**Moorhead Area Public Schools
Grades 5-6 Addition at Horizon Campus
Bid Group II
Moorhead, MN**

**Project No. 15-024
Date: May 13, 2016**

ADDENDUM NUMBER 3

A3.10

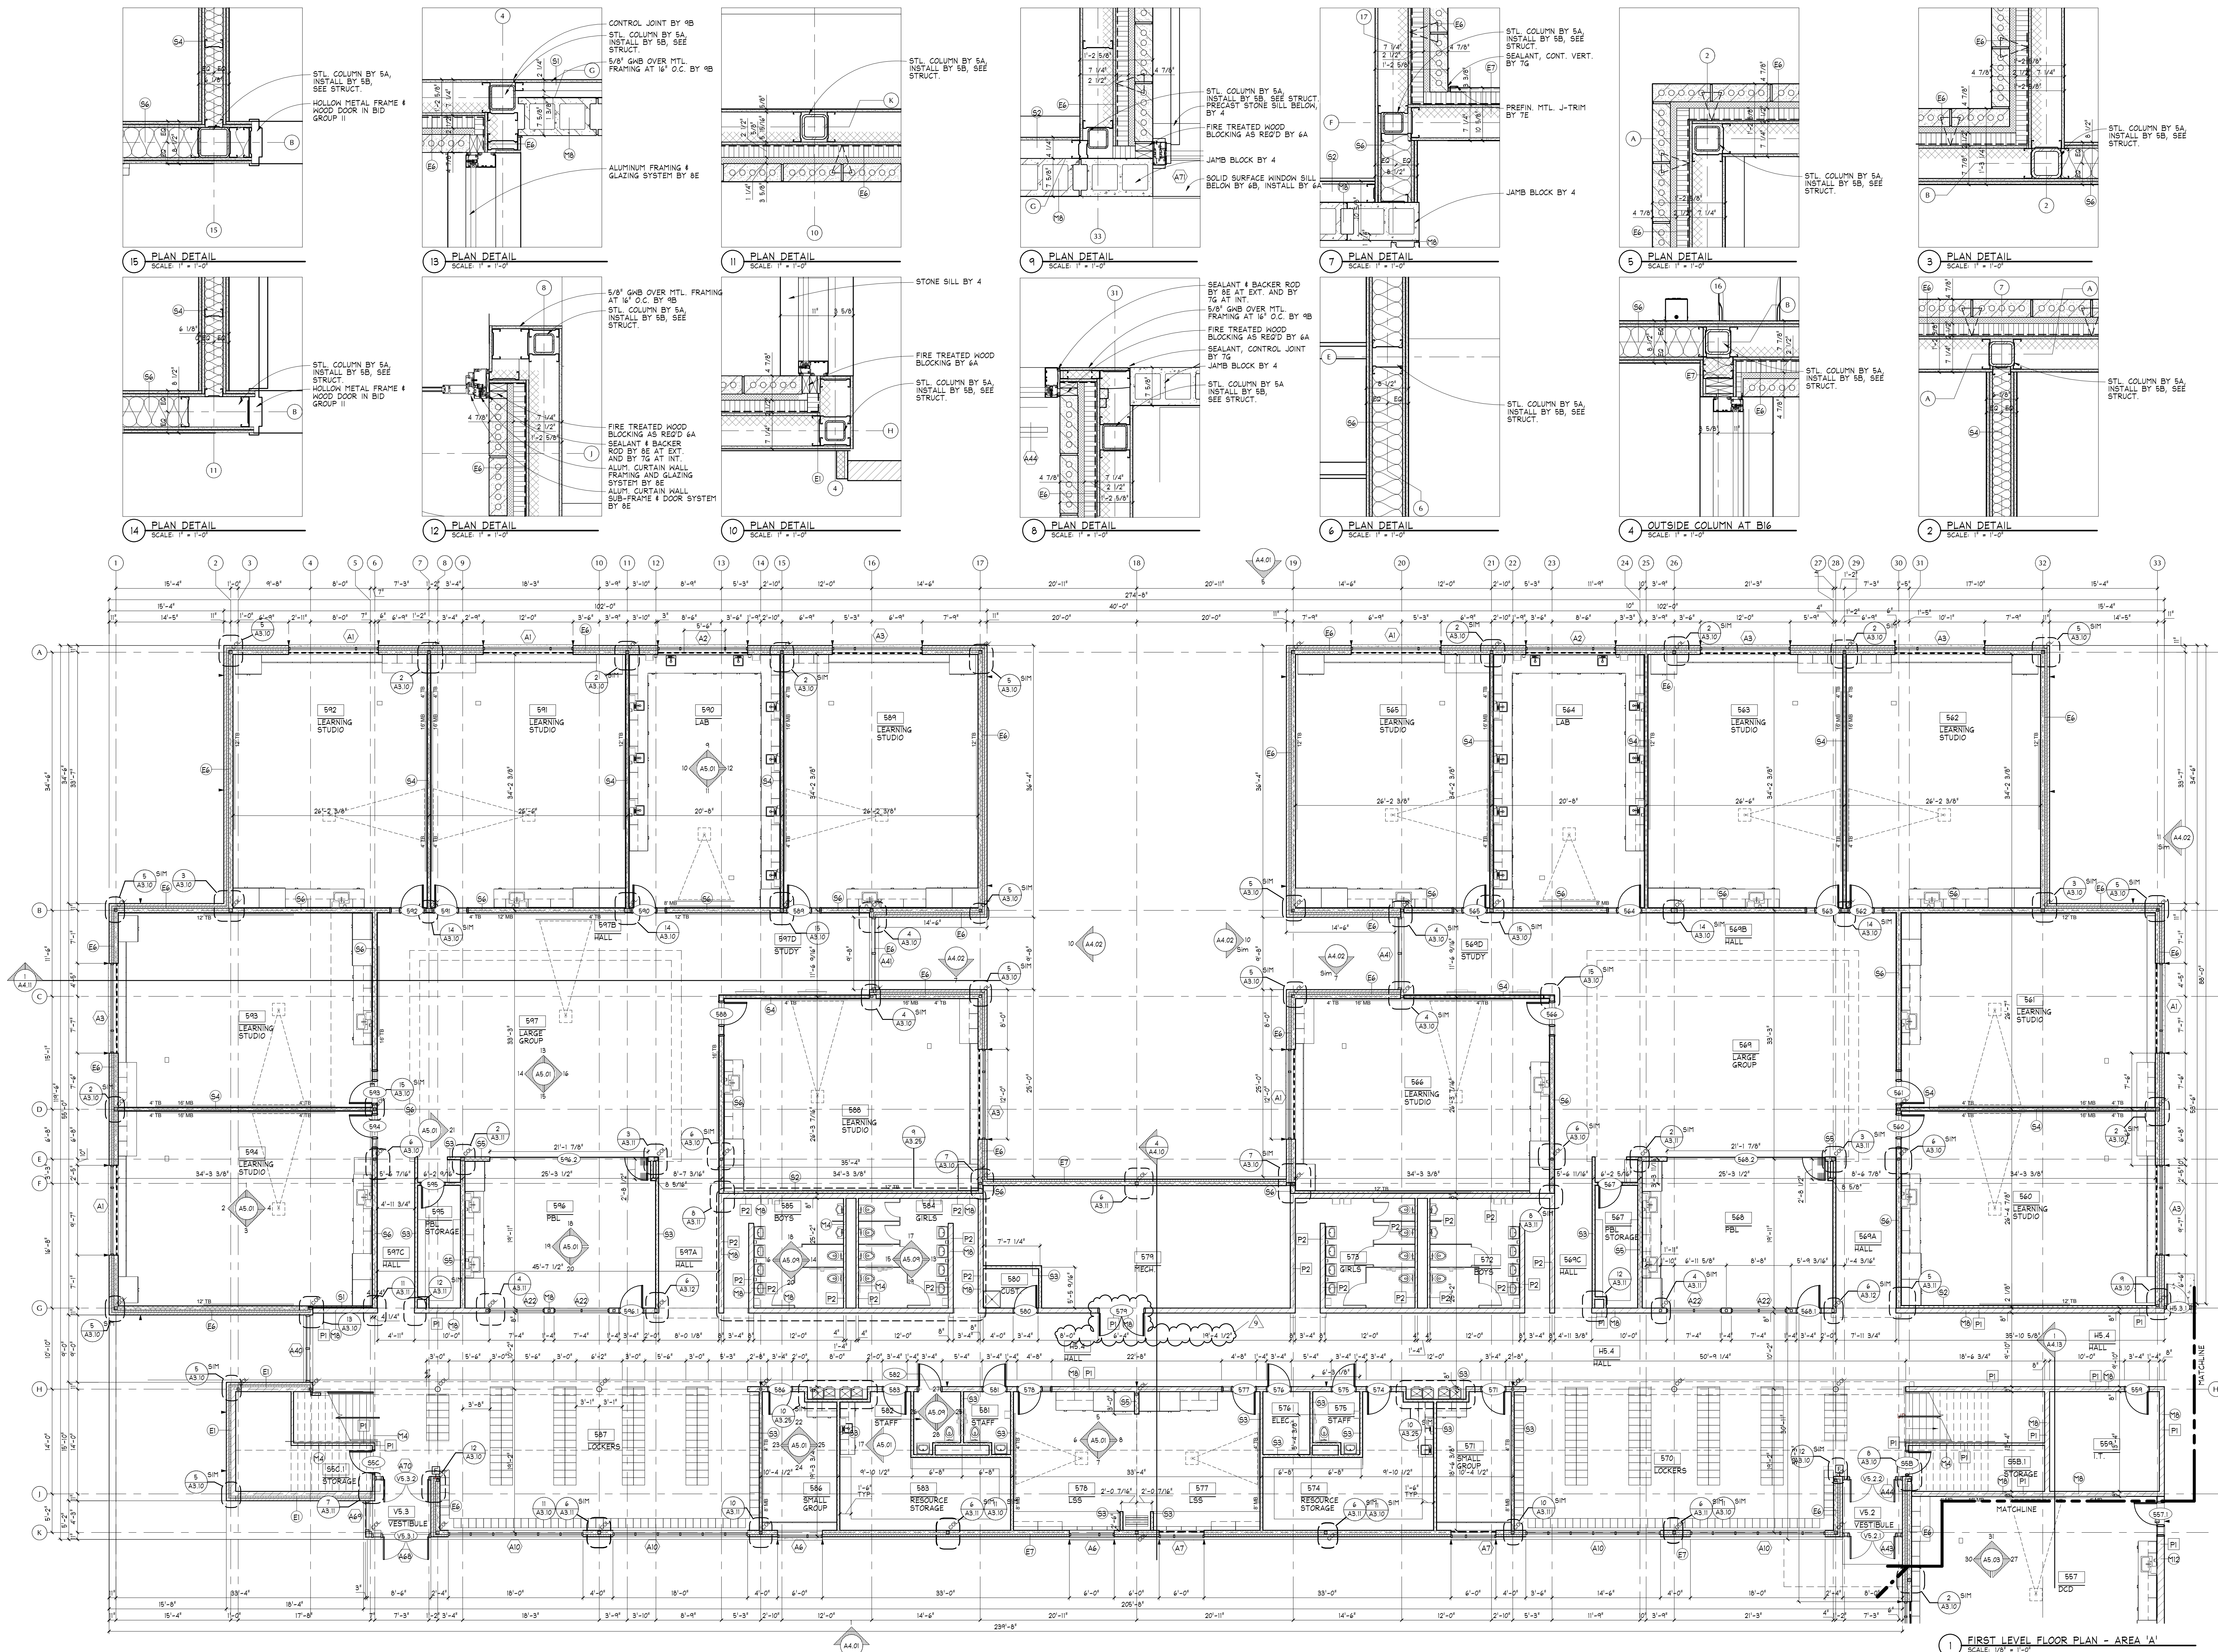
Drawing A3.10: First Level Floor Plan - Area "A"

1. Drawing revised for mechanical room door locations.

FIRST LEVEL FLOOR PLAN - AREA "B"

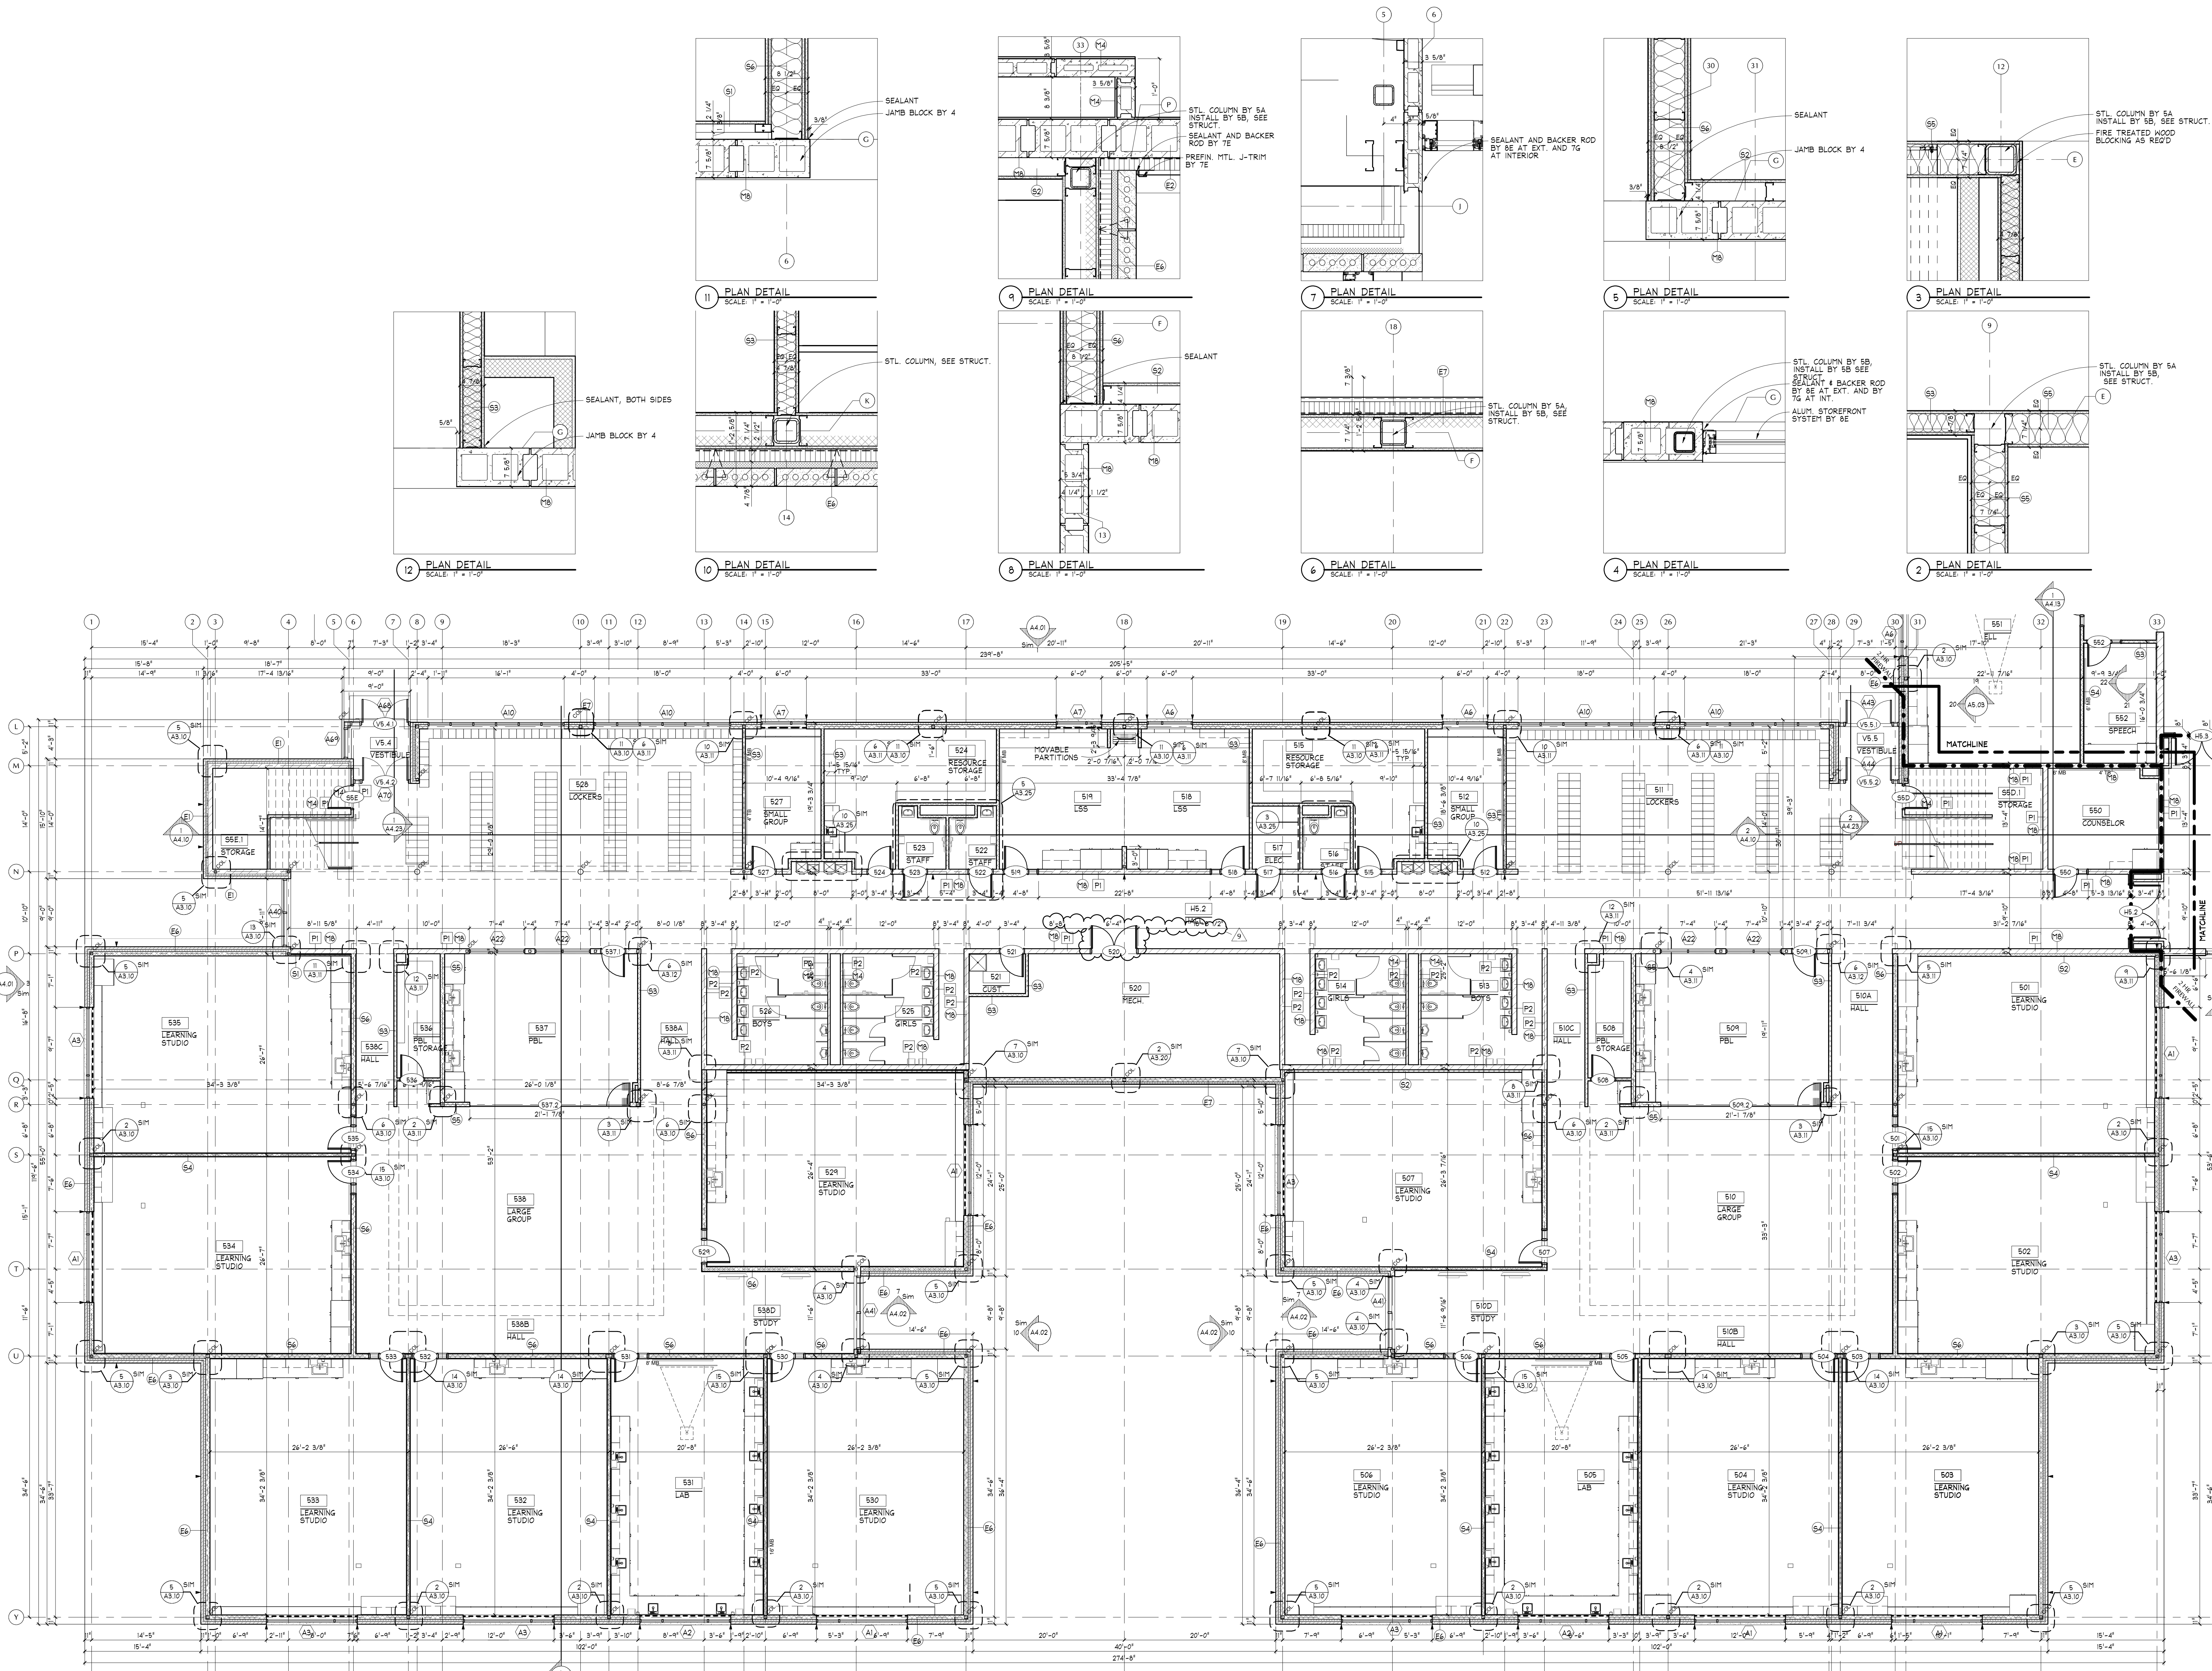
Drawing A3.11: First Level Floor Plan - Area "B"

1. Drawing revised for mechanical room door locations.

FIRST LEVEL FLOOR PLAN - AREA "C"

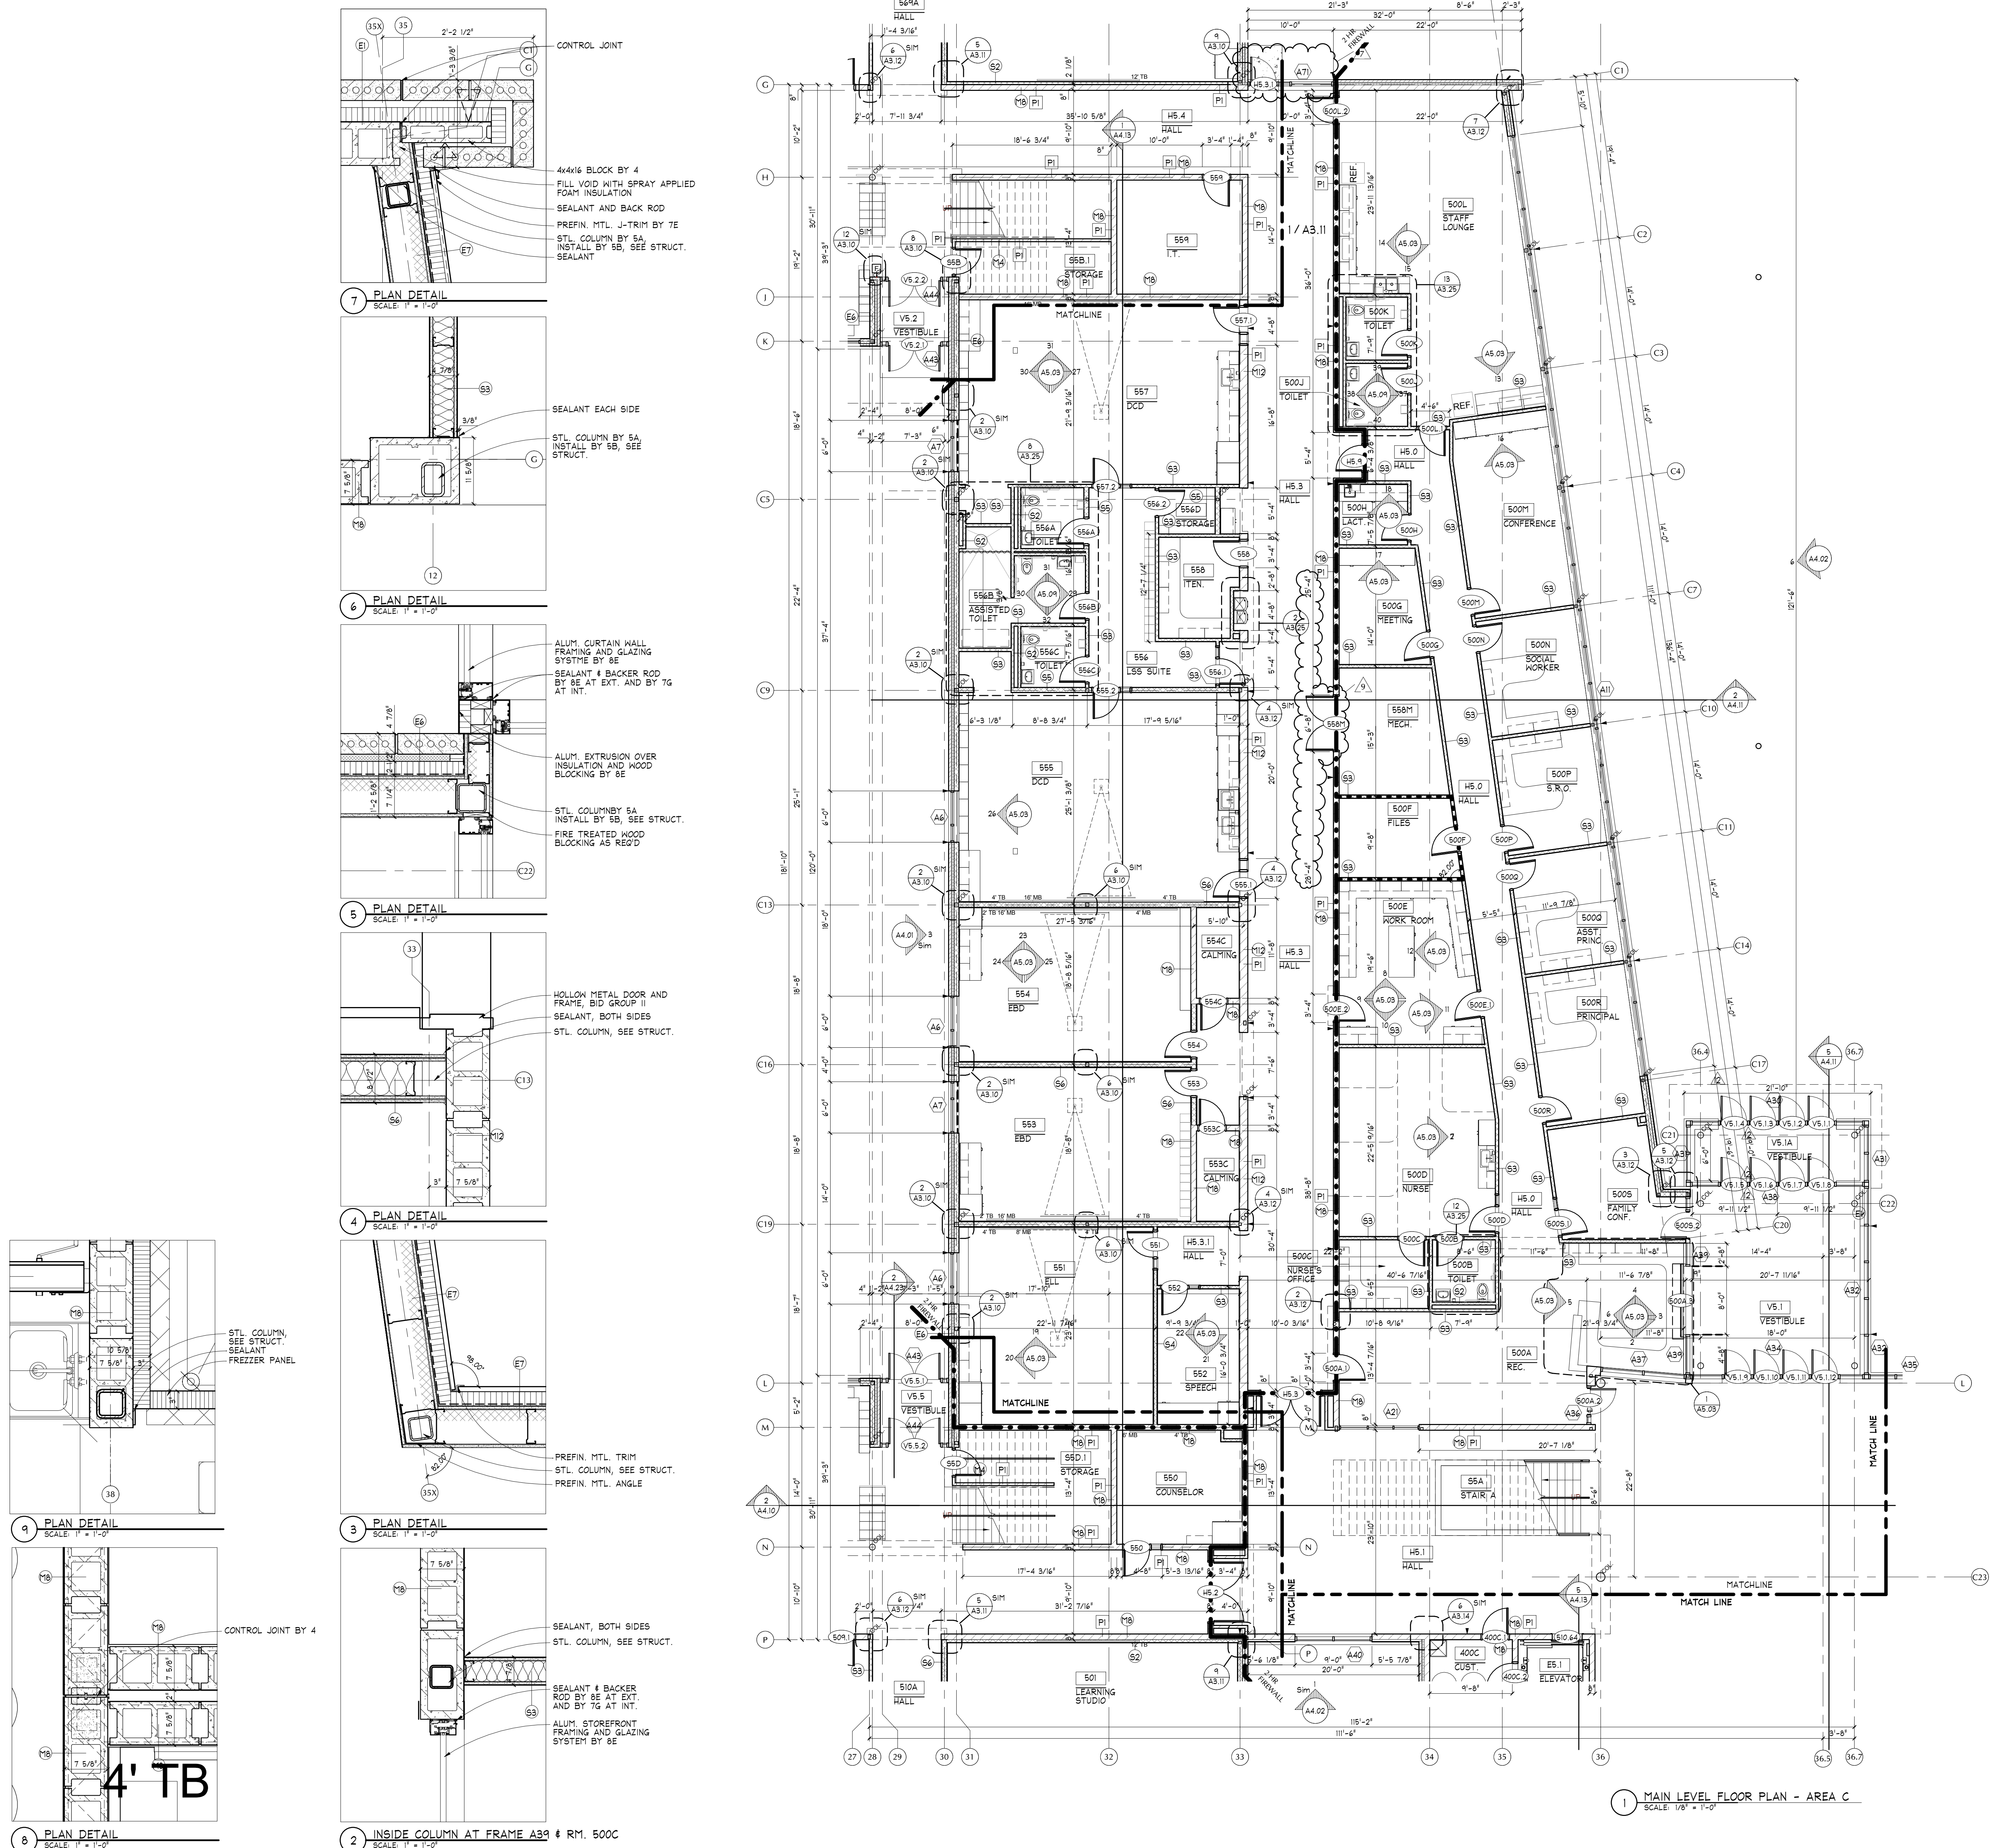
Drawing A3.12: First Level Floor Plan - Area "C"

1. Drawing revised for mechanical room door locations.
